MONTGOMERY COUNTY PLANNING DEPARTMENT
THE MARYLAND-NATIONAL CAPITAL PARK AND PLANNING COMMISSION

PLAN NAME: Town of Somerset Bathhouse

PLAN NUMBER: MR2010737

PLAN TYPE: Forest Conservation Plan

Sheet 4 of 5
FOREST CONSERVATION PLAN

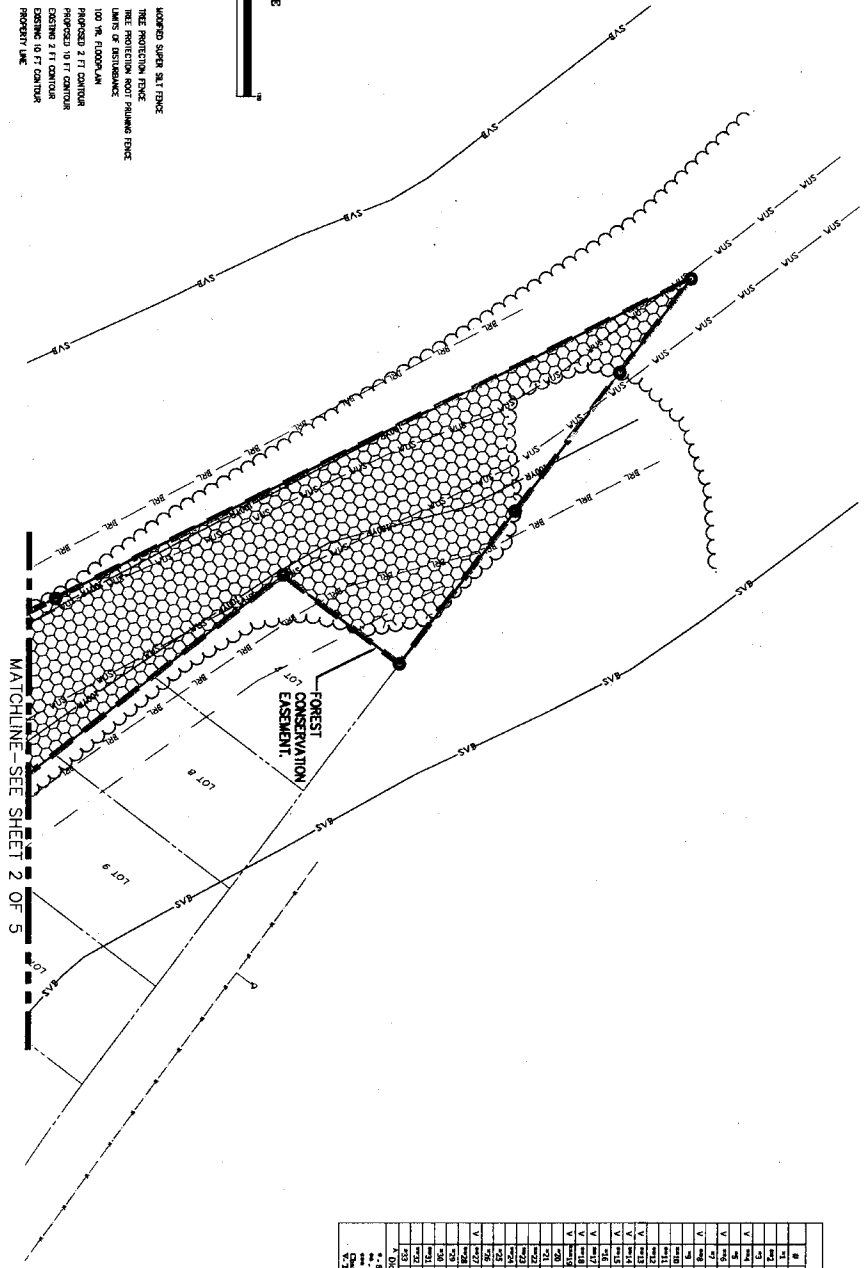
Tree #4- This tree is at a corner of the existing parking lot and a significant portion of the CRZ is under the parking area. A small strip of asphalt is being removed to existing reduce impervious area, especially within the stream valley. This was a request of environmental staff during an early visit to the site prior to finalizing plans. A note on the FCP requires that the asphalt be removed without the use of heavy equipment in the CRZ.

Tree #6 - This tree resides approximately 10' from the existing parking lot. The green island here is being replaced with parking and a small area of re-grading. This tree also has a significant portion of the CRZ under the parking area. The preference is to try to save the tree even though the impact is close to the trunk. The impacted area is so small that the tree should survive. Root pruning is proposed.

Tree #8- Similar to tree #6, this tree resides approximately 10' from existing parking and will experience minor disturbances from the proposed re-grading. This tree is the mirror image condition of tree #6 and the same handling of the tree is proposed.

Tree #13- This tree is approximately 5'-7' from an existing storm drain pipe. The proposed storm water management plan adds a rip rap at the outfall at the end of the pipe. There will little to no regarding for the installation of the rip rap. The impact to the CRZ is the result of the grading for the bio-filter at the outskirts of the CRZ. Root pruning is proposed.

Tree #14- This tree is off-site by 26'. The proposed installation of retaining wall and storm drain pipe that will impact less than 1% if at all, of its CRZ. There is no evidence on the hillside coming down to the wall that tree roots are present. This construction should not affect the long term health of this tree. Root pruning is proposed.

Tree #15- This tree is off-site by 10'. The proposed installation of retaining wall and storm drain pipe that will impact approximately 22% of its CRZ should not affect the long term health of this tree, but the condition of the tree is listed as poor on the approved NRI and now appears dead.

Tree #17- This tree is off-site by 5'. The CRZ of this tree is impacted by the construction of a retaining wall that will be approximately 5' high on the pool side. The CRZ impact is negligible. Root pruning is proposed.

Tree #18- This tree is approximately 20'+ away from the existing parking lot. There is an impact area of 66 square feet of grading to install a submerged wetland bio-filter. Root pruning is proposed.

Tree #19- This tree is off-site but at least one third of its CRZ currently under the pool's parking lot. There is an existing walkway adjacent to the parking lot that will be relocated closer to the parking lot. The new sidewalk will be installed on grade with root aeration matting (detail on sheet FCP 5 of 5). There is also a small bio-retention facility proposed within the CRZ. The proposed root pruning & minor grading impacts for the bio-retention pond would not be detrimental to the long term health of this tree.

Tree #27- This tree is proposed to be saved with an impacted area of 19% to the total root zone. The impacts are the result of the installation of the proposed submerged wetland bio-filtration facility which has been designed to best avoid as much as possible direct impact to the tree. An onsite visit was done with an engineer from VIKA, and a reviewer from M-NCPPC to determine the location for the SWM facility. It was agreed upon that the location selected would have the least impact to the forest as this particular area was not as densely forested as the surrounding area. Soil type also played a role in the choice, as it was more suitable for a submerged wetland facility. The tree will provide shade during the establishment of the pond plantings.

The Environmental Planning staff has reviewed the forest conservation for the project reference above. Staff recommends approval of the forest conservation plan subject to the following conditions:

1. Applicant must record a Category I conservation easement over all areas of forest retention prior to any clearing or grading occurring onsite.

As a result of the above findings Environmental Planning staff recommends the approval of the applicant's request for a variance from individual tree retention requirements of the Forest Conservation Law to impact the critical root zones of 10 trees. The variance approval is assumed into the Planning Board's approval of the forest conservation plan.
